Red Line Revision No. 1
Dated April 28, 2005

Revision "F"

MARYLAND DOT - STATE HIGHWAY ADMINISTRATION
Office of Traffic & Safety
TRAFFIC ENGINEERING DESIGN DIVISION
(Traffic Signal Plan)

MD 28 (W. Montgomery Avenue) at Nelson Street /I-270 NB Off Ramp

T.S.-244F — Log Mile-15002826.09

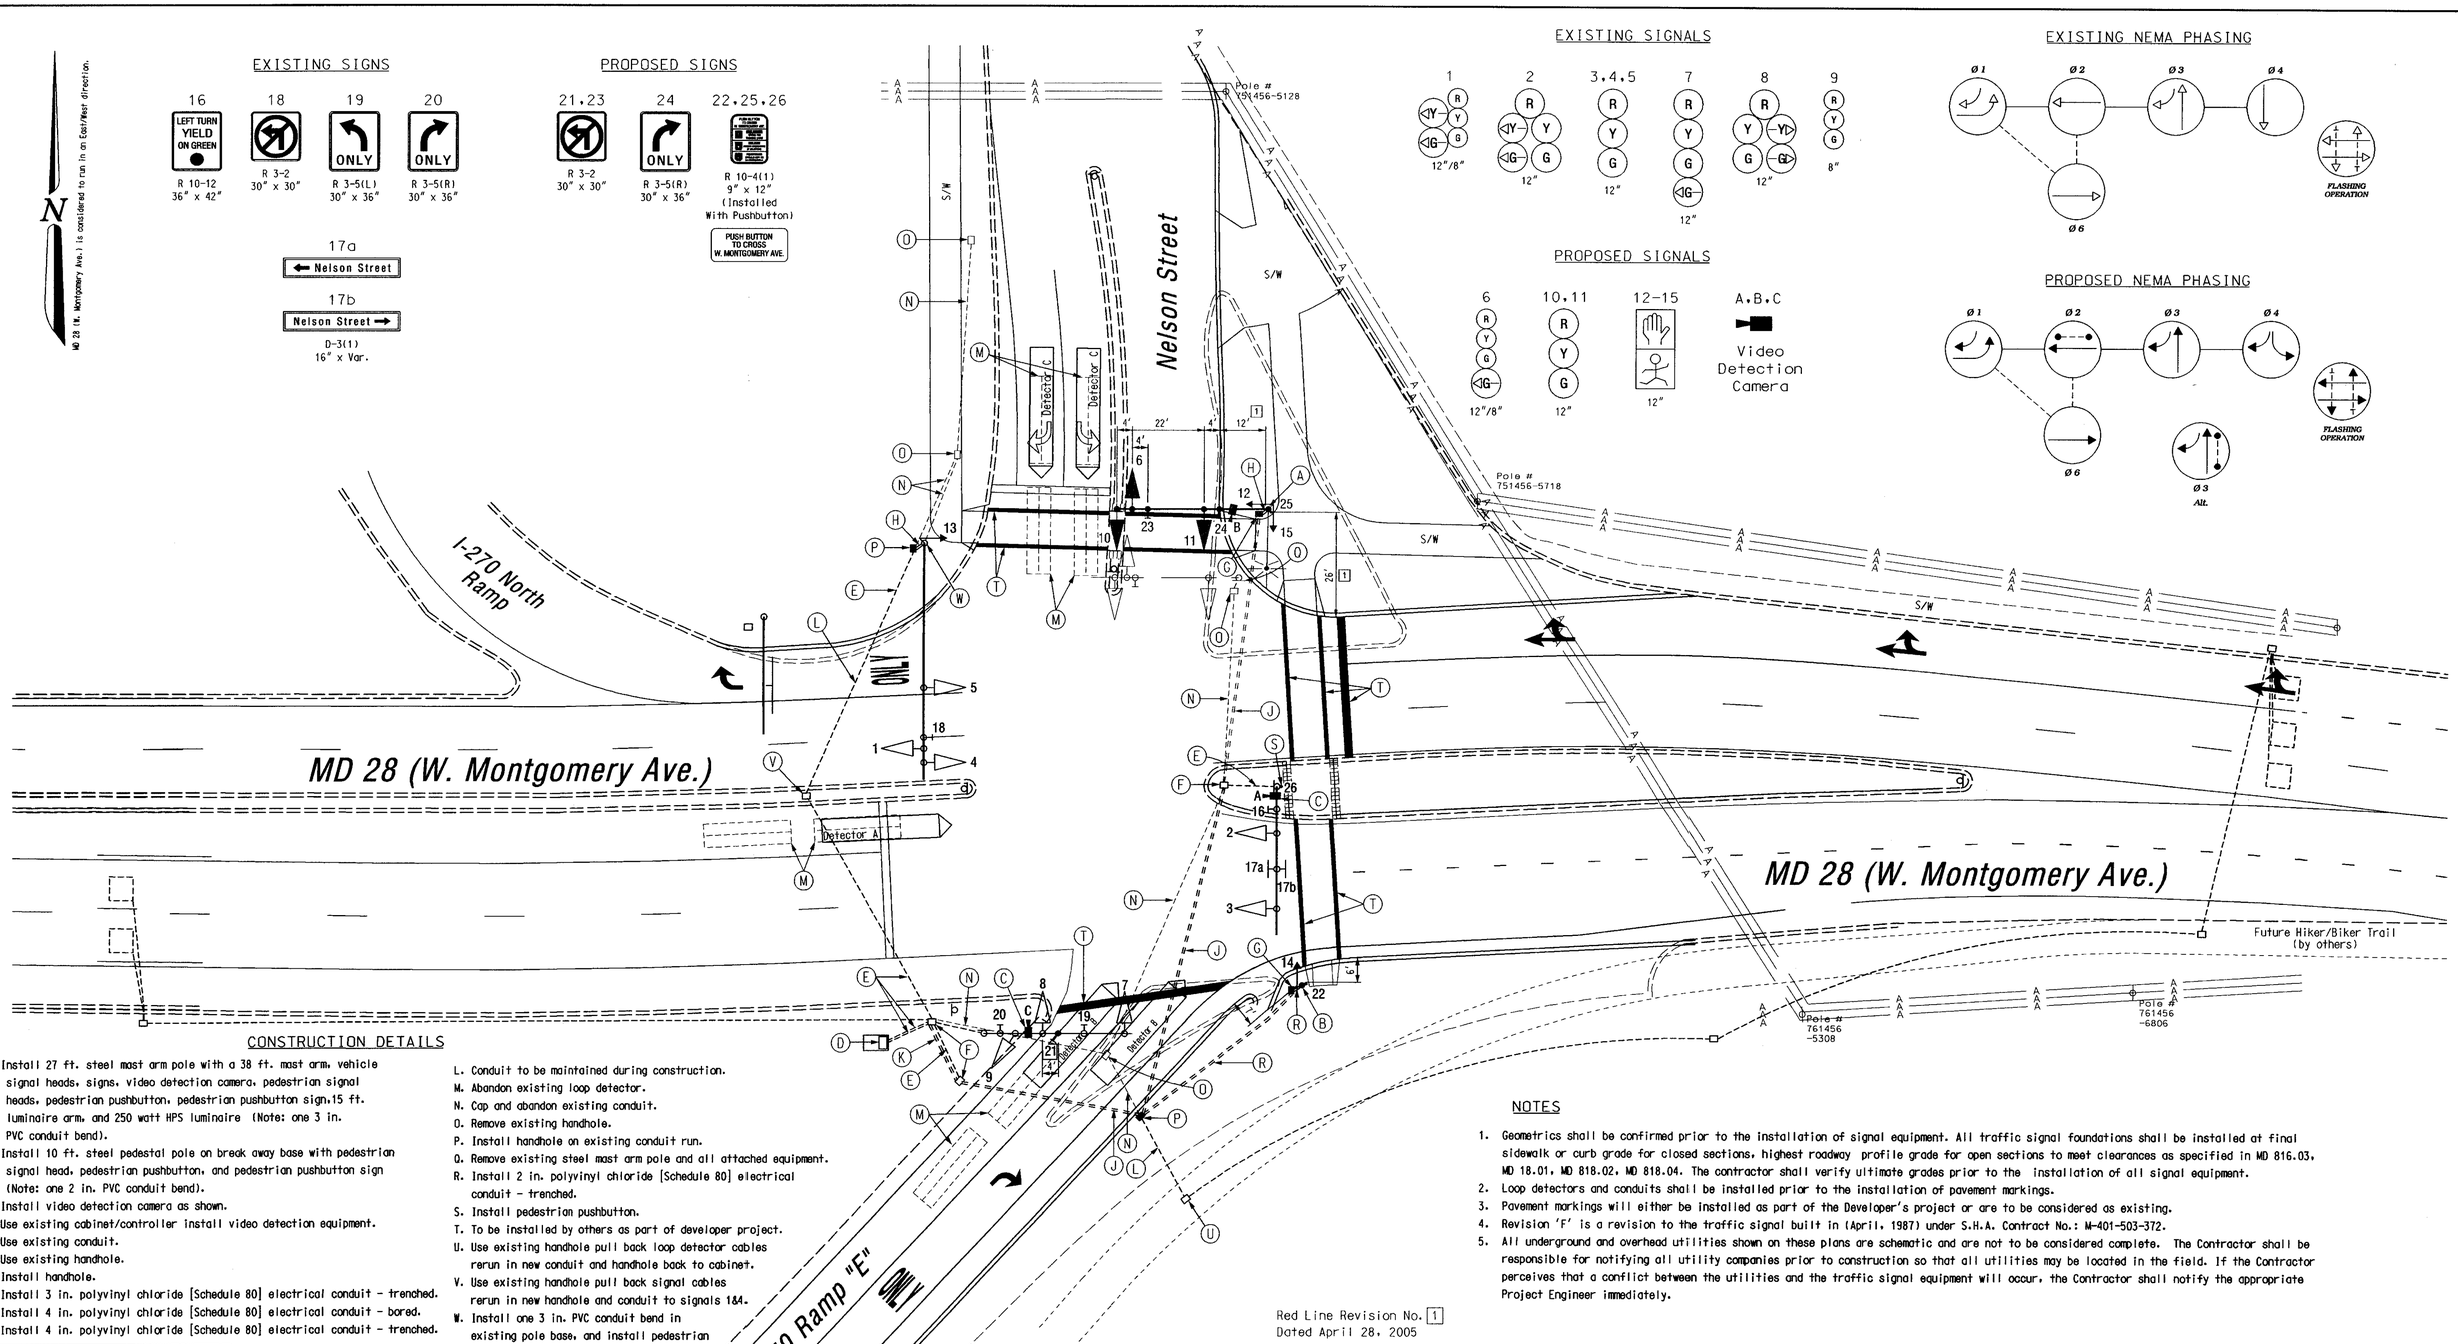
REVISIONS					
(F) Modifications due to new geometrics. S.H.A. No.:BW996M82 March 23, 2004					
fdb					
(E) Right-turn overlap for Phase 3. S.H.A. No.:M-401-503-372 Oct. 15,1999					
JES					
(D) Right-turn overlap for Phase 3. S.H.A. No.:M-401-503-372 June 11,1992					
(C) Reloc. Sig. Equip. Due to Gem. Imp. S.H.A. No.:M-401-503-372 Oct. 30,1986					
ZS					TH
